ADDENDUM NO. CC-2

March 16, 2026

Lewis Central Community School District
Athletic Building Addition & Renovation
3820 Harry Langdon Blvd, Council Bluffs, IA 51503
BCDM Project No. 5551-05

NOTICE TO BIDDERS: The Project Manual and Drawings for the above-mentioned project are hereby amended as follows:

UPPER LEVEL FRAMING PLAN AND DETAILS

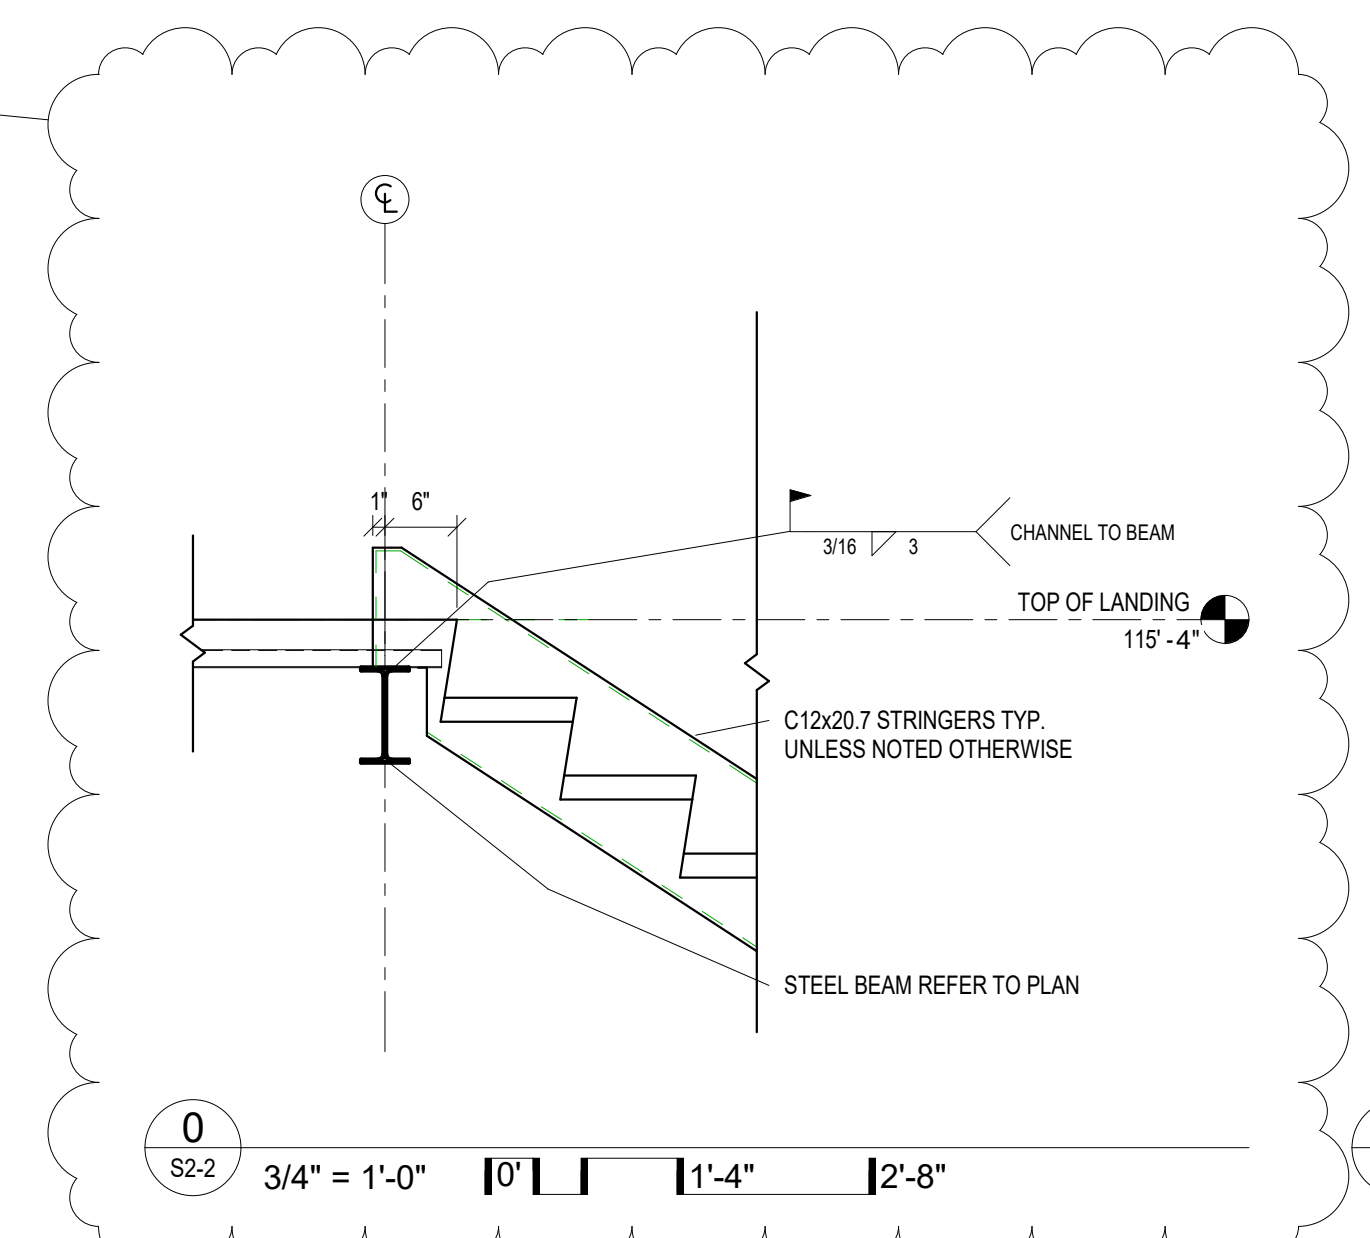
- a. See detail 1/S2-2 on the attached sheet for support for the mat hoist supports.
- b. See Roof Keynotes for added keynote 305.

- 207 REFER TO DETAILS S2-2 & S2-2 FOR STAR STRINGER CONNECTION TO LANDINGS
- 305 DESIGN MAT HOIST BEAM FOR (2) 12K HOIST REACTIONS VERIFY LOAD AND LOCATION WITH MAT SUPPLIER

**FLOOR PLAN - FIRE
 SUPPRESSION**

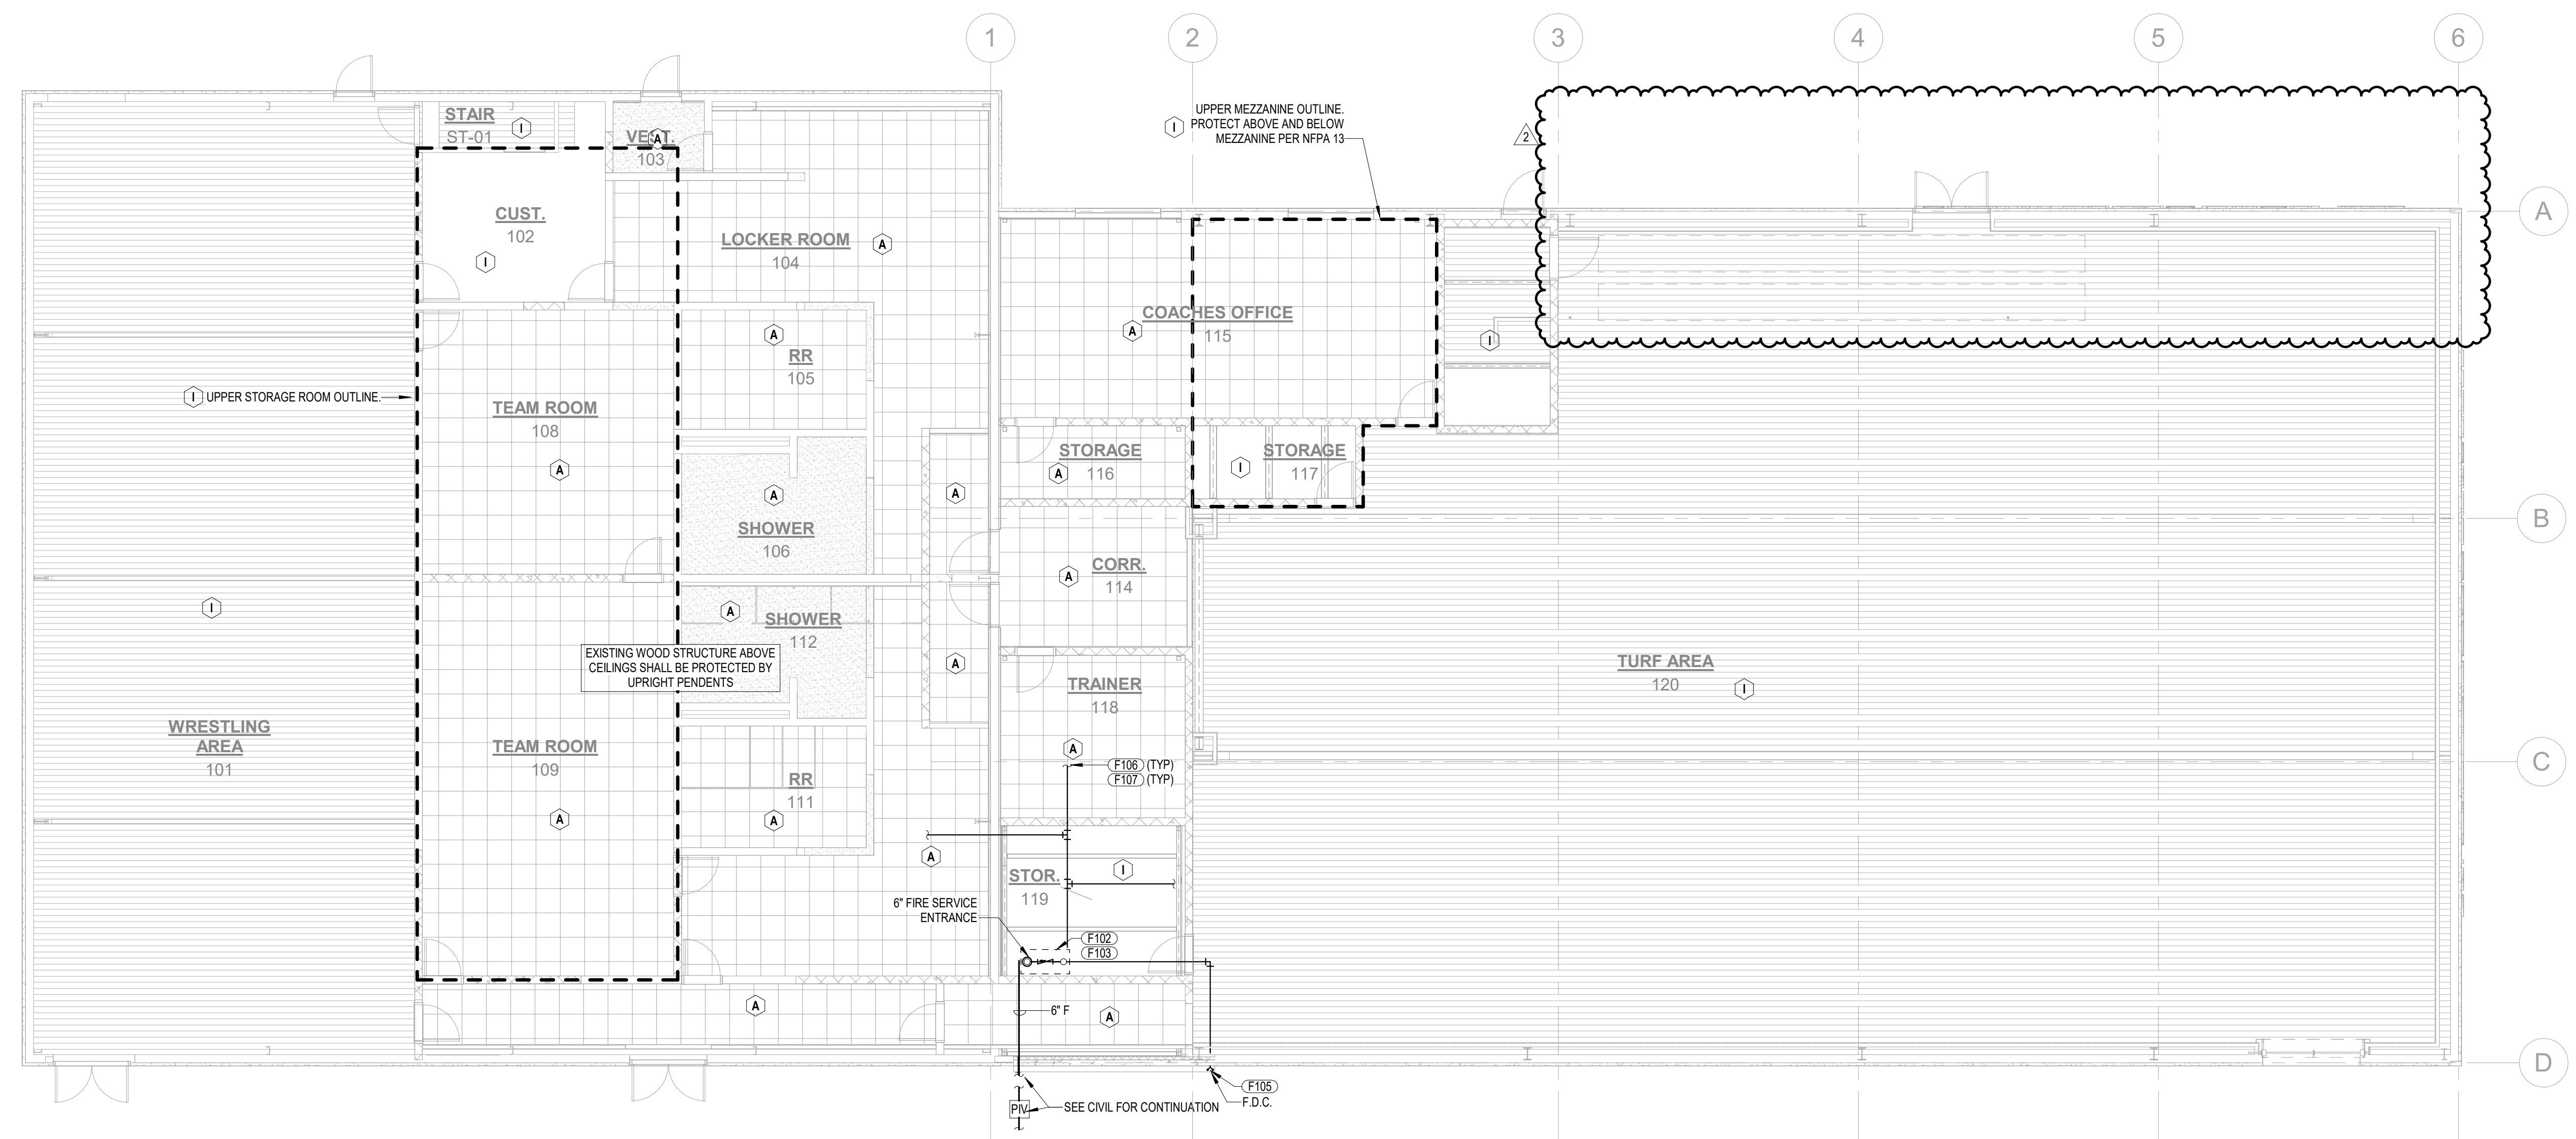
1. Sheet F1-1 – FLOOR PLAN – FIRE SUPPRESSION
 - a. See attached sheet for revised fire suppression in TURF AREA 120.

FLOOR PLAN -
LIGHTING

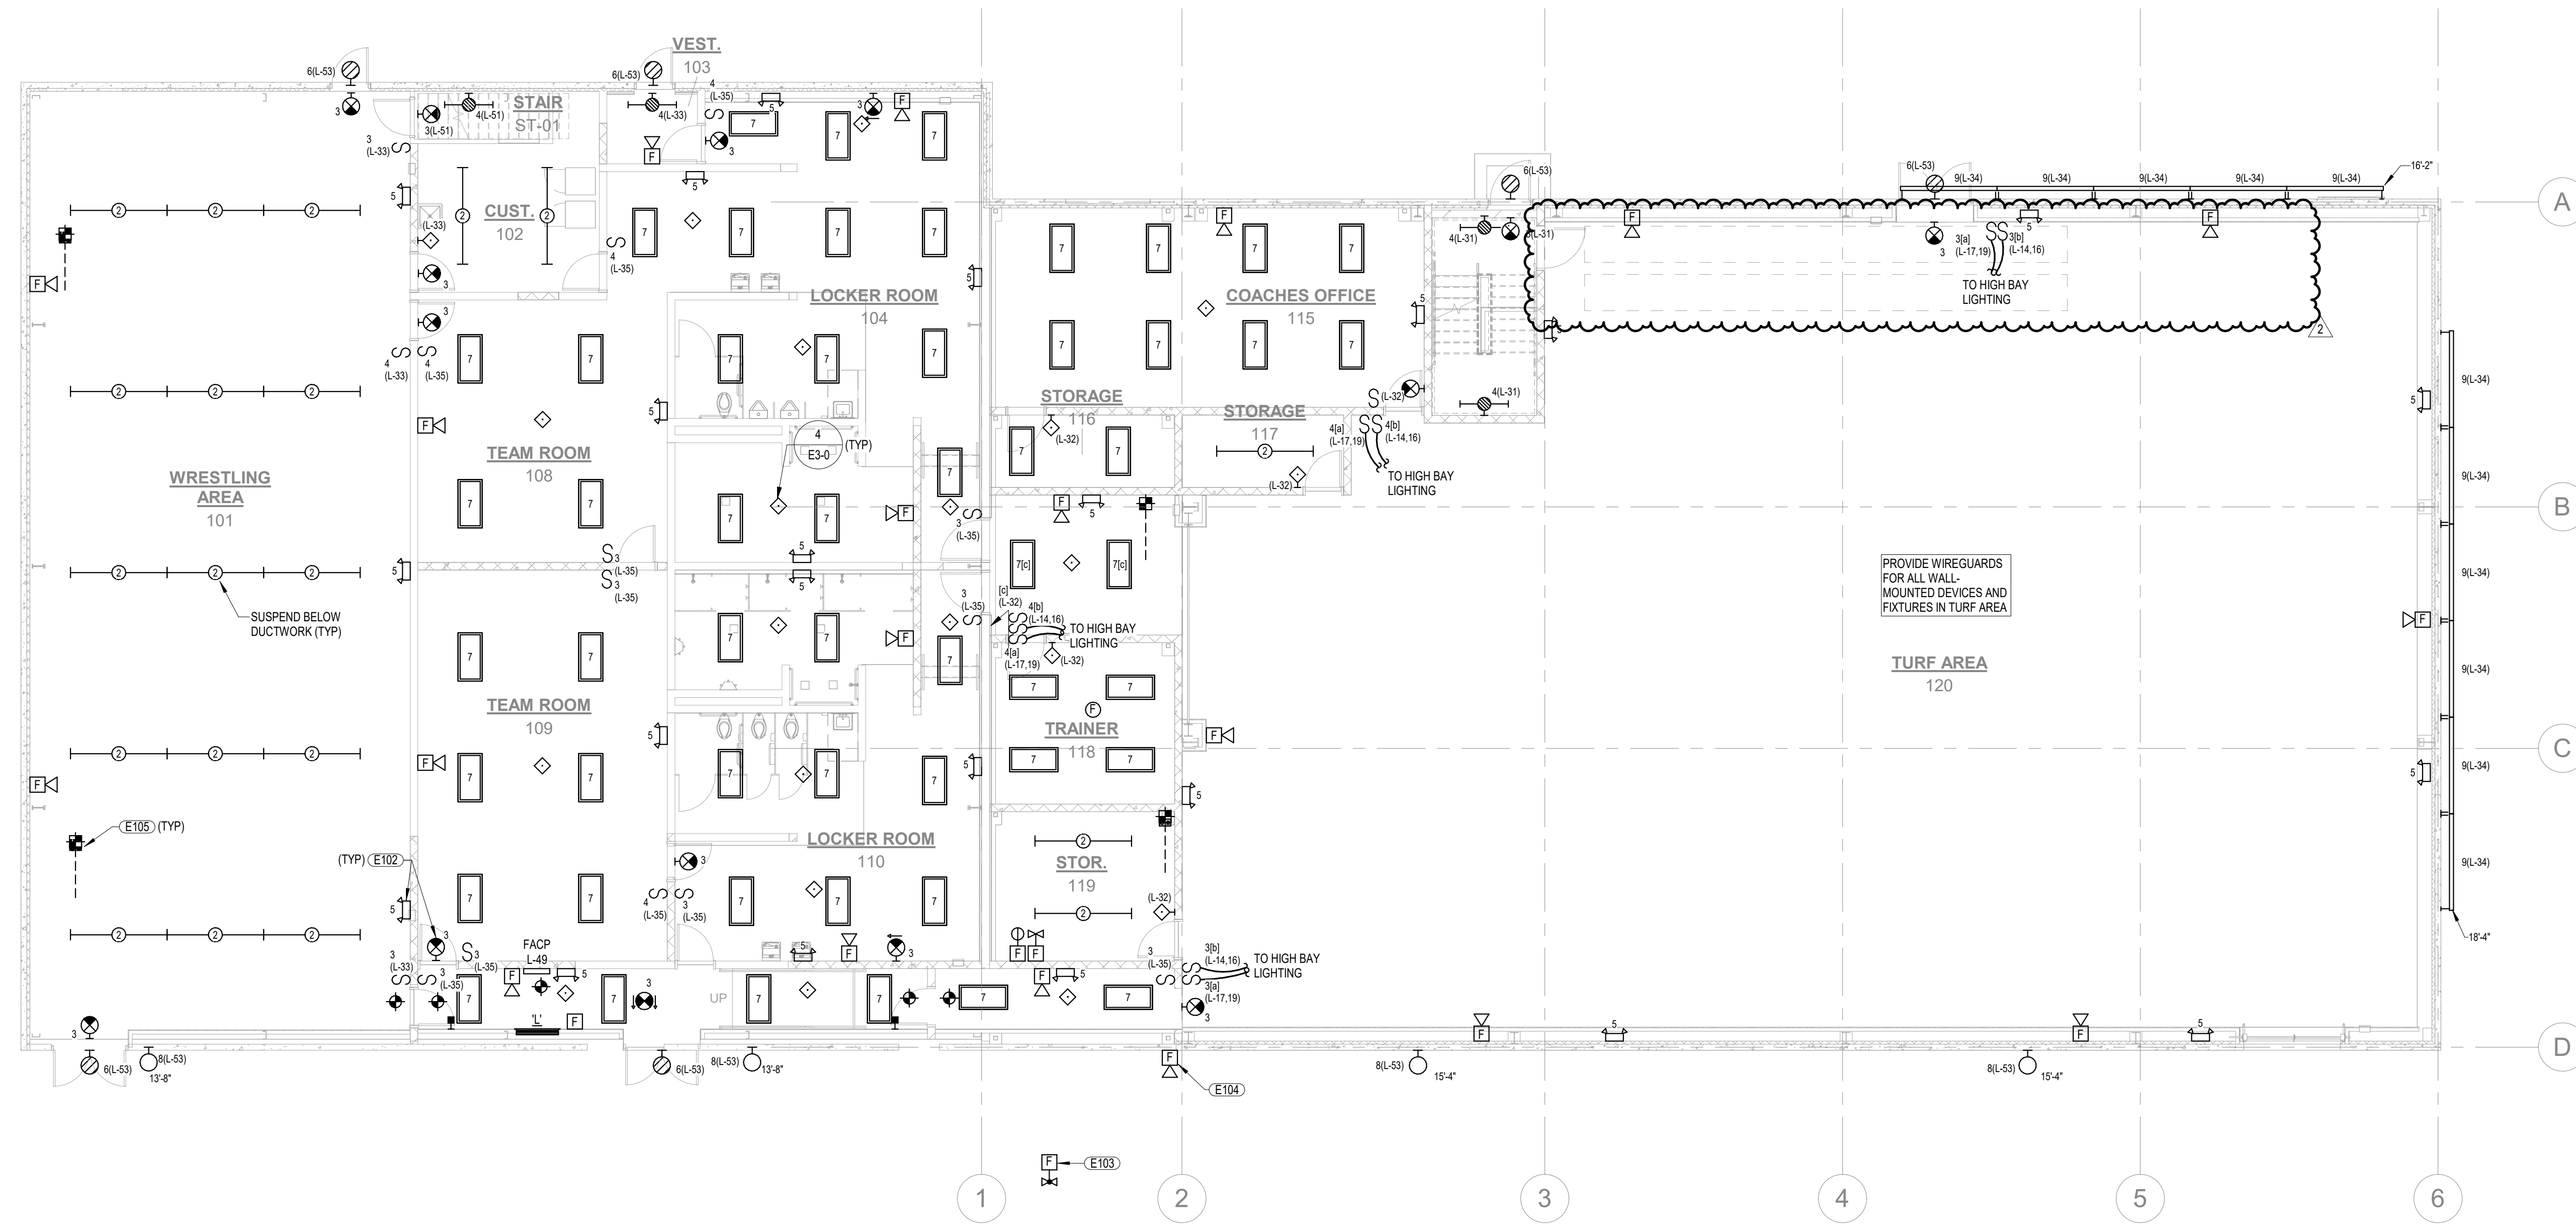
1. Sheet E1-0 – FLOOR PLAN - LIGHTING
 - a. Remove lighting and switching.
2. Sheet E1-1 – UPPER LEVEL – LIGHTING
 - a. Remove lighting and switching.
3. Sheet E2-0 – FLOOR PLAN – POWER
 - a. Add switches for mat hoists.
4. Sheet E2-1 – ROOF PLAN/UPPER LEVEL – POWER
 - a. Add connections for mat hoists.
5. Sheet E4-0 – ELECTRICAL SCHEDULES
 - a. Revise panel schedule.
